From: [Adam Trimble](#)
To: [Julie Adams](#)
Subject: RE: Questions for the LMN consultants: Columbia Theatre Certificate of Appropriateness - ActionItem:00007:hopql
Date: Tuesday, May 06, 2008 8:31:34 AM

COLUMBIA THEATRE - ROOFTOP MECHANICAL SCREENING PROPOSAL

NORTH ELEVATION - AFTER

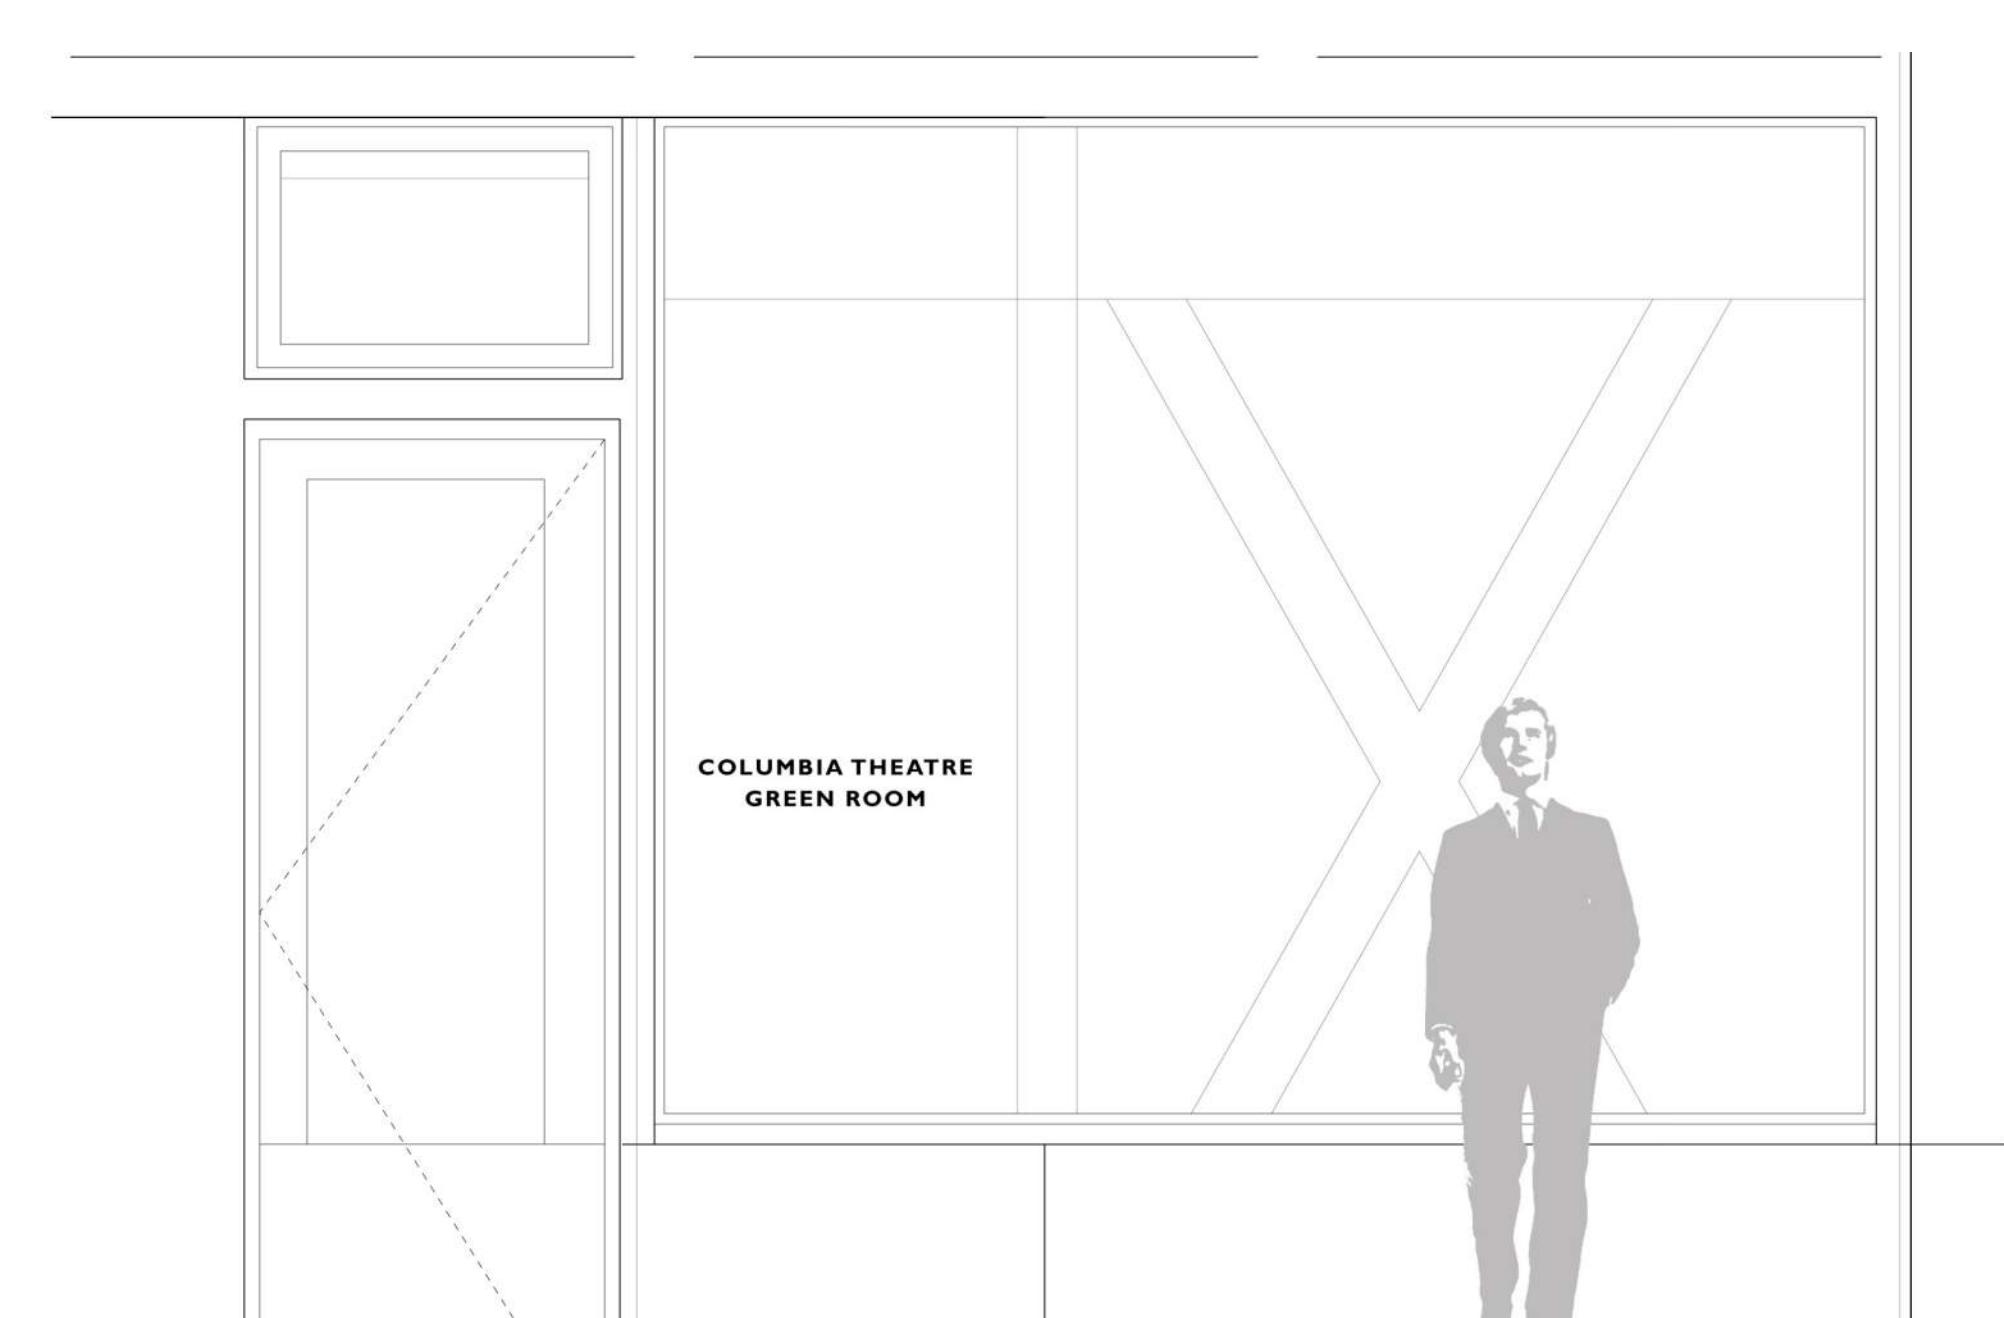
5) Mr. Thomas Hill and other commissioners noted concerns about the roof top mechanical screening walls. The commission would like to see textural options for the walls.

- a. Exterior façade critical to the historic preservation commission.
- b. Please give a compete overview of the changes to the façade including; detail on the mechanical installations, the visual impact on the building from the street and from the apartments. Including also, details on the air intake- located on the north roof (of the pepper theater).

LMN Response: *We agree with the assessment that the exterior mechanical screen walls should relate to the existing building. Please see attached plans, sketches and details that have been developed to illustrate the proposed design.*

7 ENLARGED PARTIAL SITE PLAN

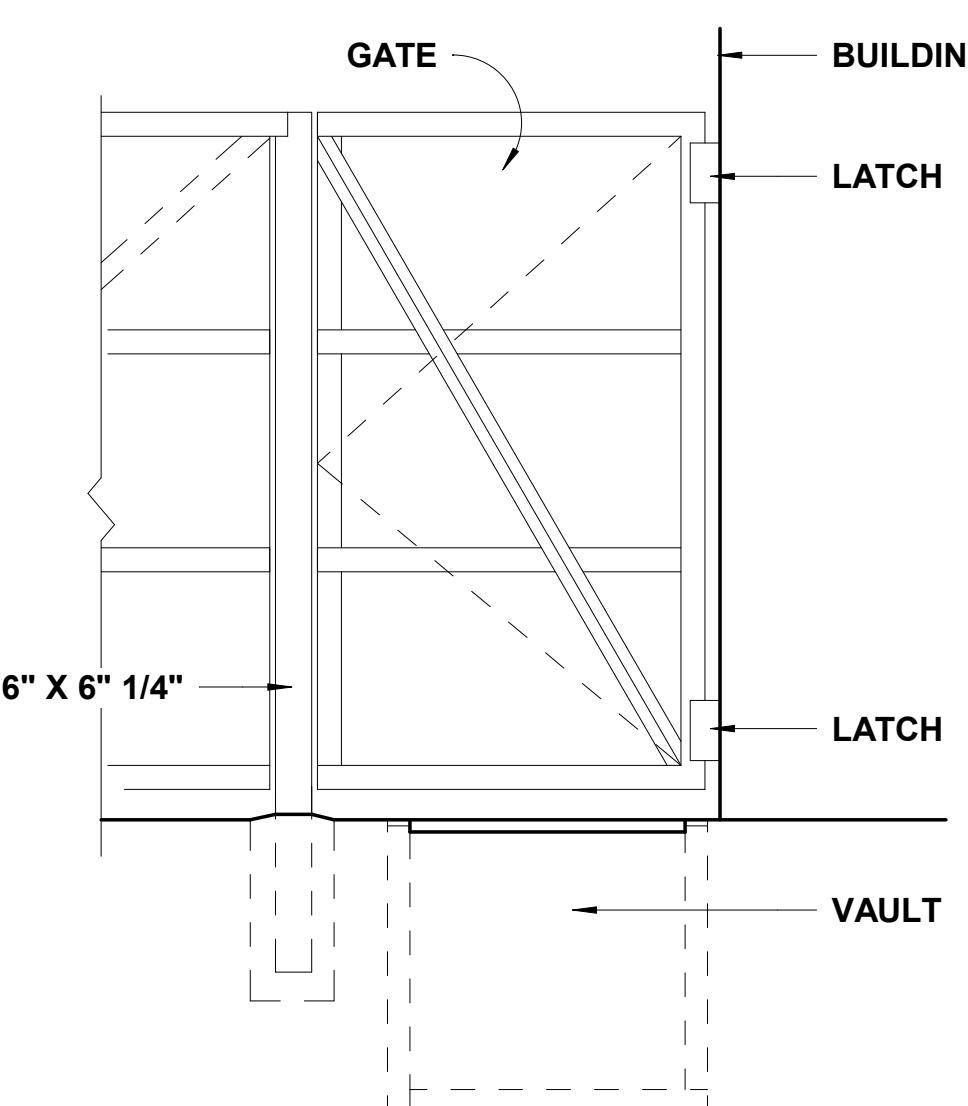
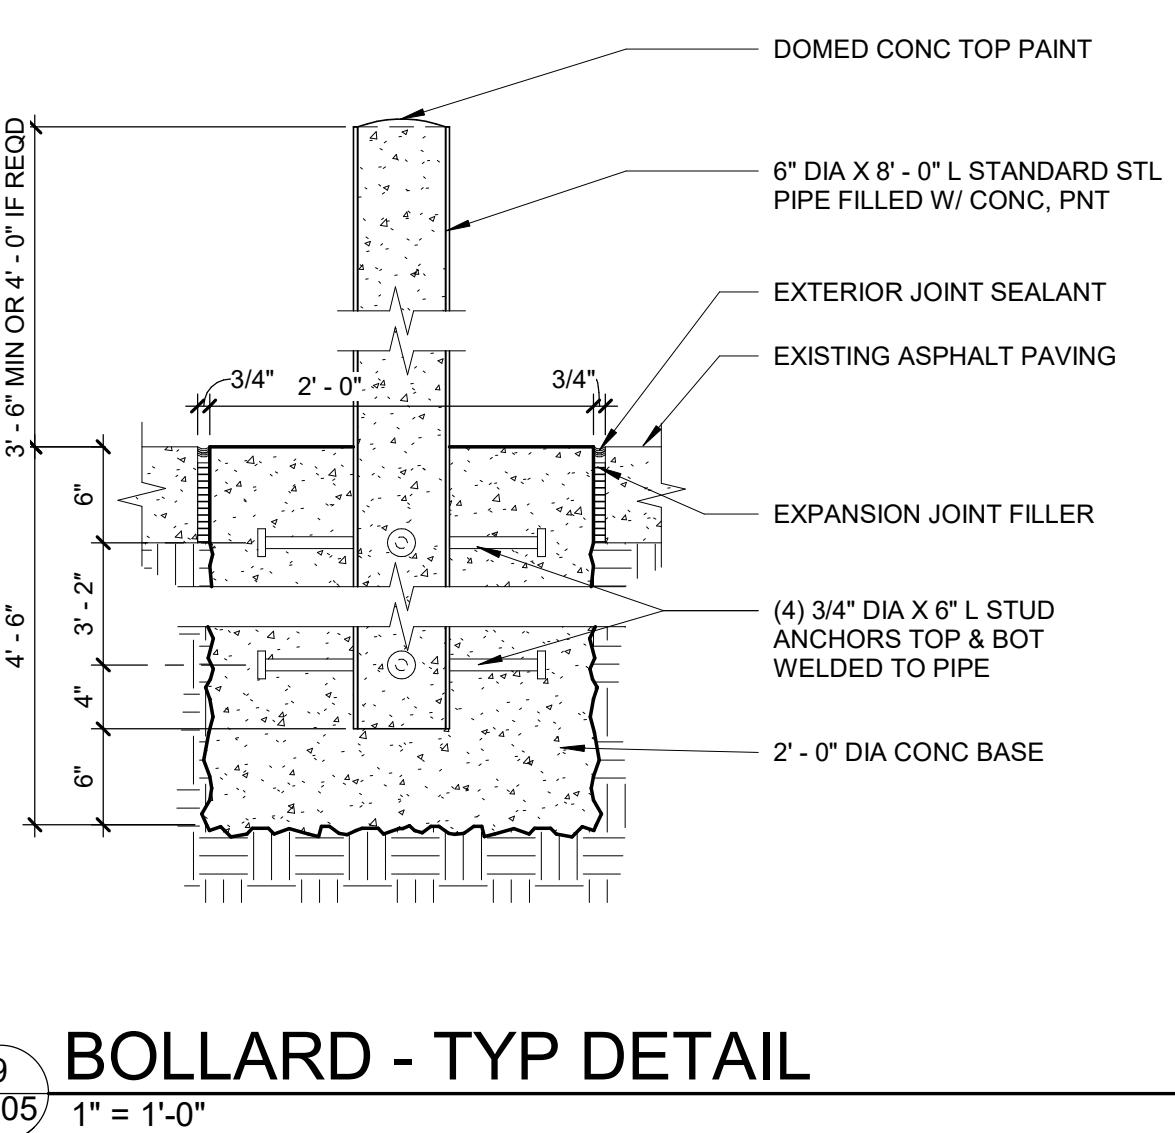
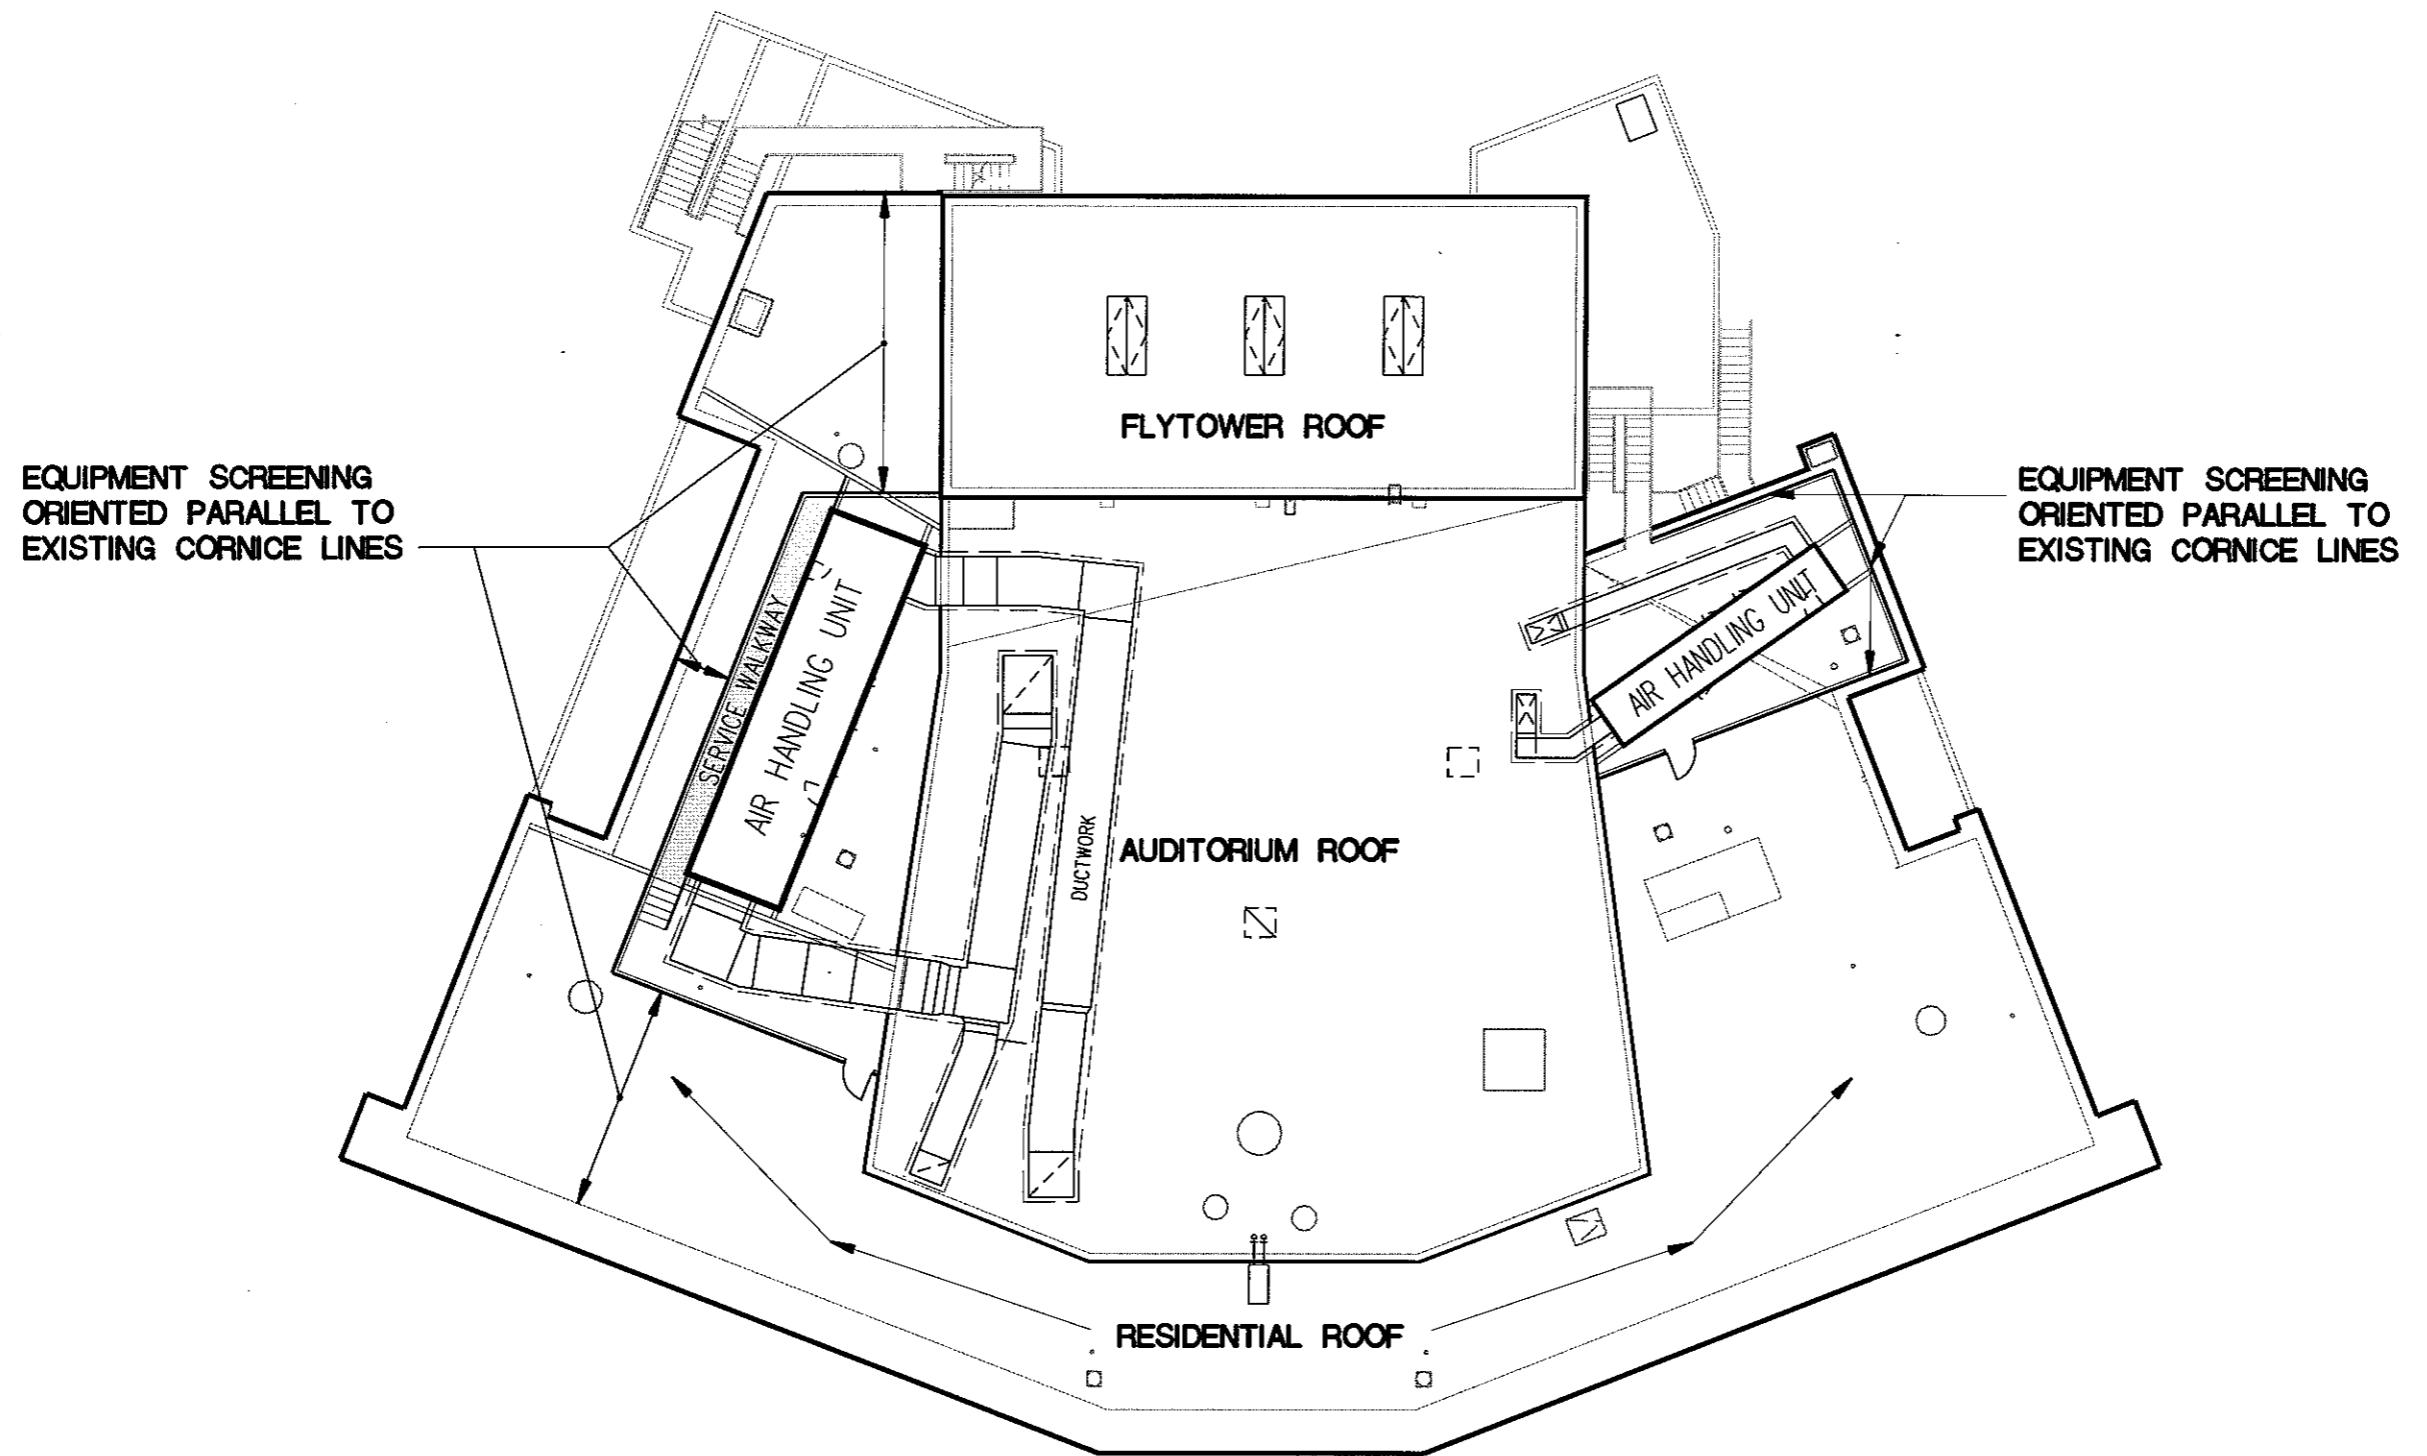
- 2) Mr. Hanna also asked about the proposed fencing around an optional proposed air conditioning unit to be located in the parking lot. Questions were raised about noise levels, the visual aspects of the screen or masking fence, and the impact on the parking stall count. More information on this AC unit proposal is desired.
 - a. Commission desires total compatibility with the existing facades...
 - b. Commission would like to see notation that the proposal is sensitive to, and accommodating of, the tenants and surrounding businesses.

LMN Response: *We are working to finalize details that will meet these suggestions.*
